### MINERALS PROGRAM INSPECTION REPORT PHONE: (303) 866-3567

<b>MINE NAME:</b> Cresson Project	<b>MINE/PROSPECTING ID#:</b> M-1980-244	<b>MINERAL:</b> Gold	<b>COUNTY:</b> Teller
<b>INSPECTION TYPE:</b> Aerial Inspection	<b>INSPECTOR(S):</b> Timothy Cazier	<b>INSP. DATE:</b> March 16, 2020	<b>INSP. TIME:</b> 11:39
<b>OPERATOR:</b> Cripple Creek & Victor Gold Mining Company	<b>OPERATOR REPRESENTATIVE:</b> None	<b>TYPE OF OPERATION:</b> 112d-3 - Designated Mining Operation

Photo 14. Carlton Tunnel outlet and Disturbed area to the south (looking east).

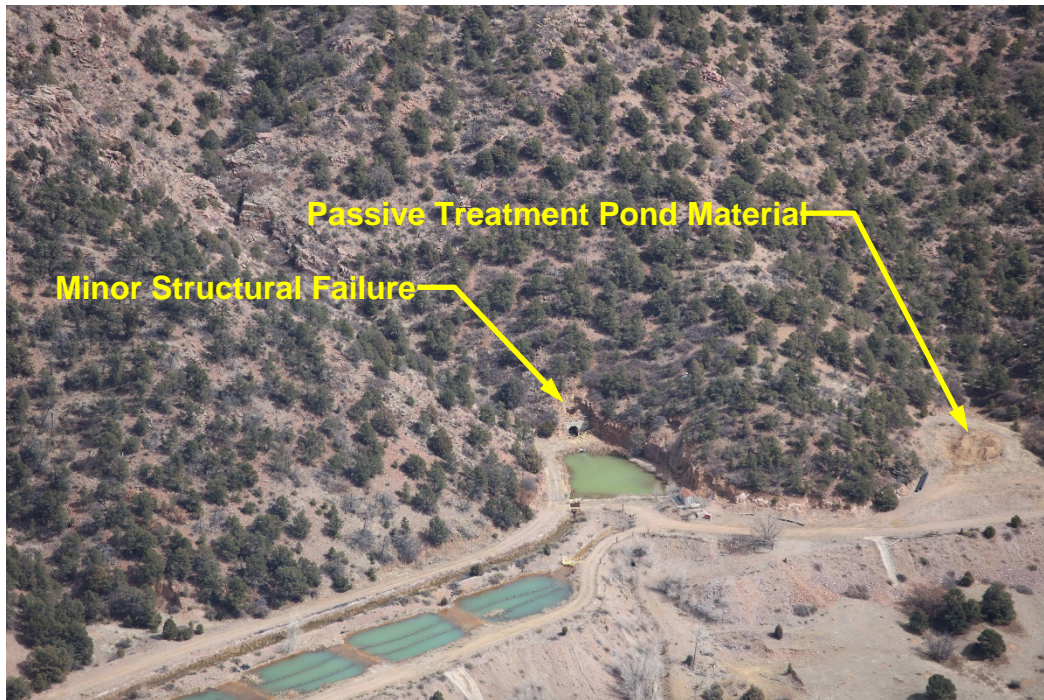
Carlton Tunnel: On March 10, 2020, the Division received notice from CC&V of a minor structural failure in the Carlton Tunnel. As such the Division included the area in this aerial inspection. The failure was too small to be

clearly observed in the aerial images taken (see **Photo 14**). A disturbed area was observed south of the tunnel opening. A telephone conversation with Mr. Justin Bills (CC&V) on March 19<sup>th</sup> confirmed the material in this disturbed area is what is removed from the five passive treatment ponds (see **Photo 15**) through which the discharge from the Carlton Tunnel flows, during regular maintenance. Records reviewed at this time are unclear as to whether or not this area is in the permit and affected area boundary. Mr. Bills agreed to research their records for clarification. The Division will follow up with this and visit the area as part of a future on-site inspection.
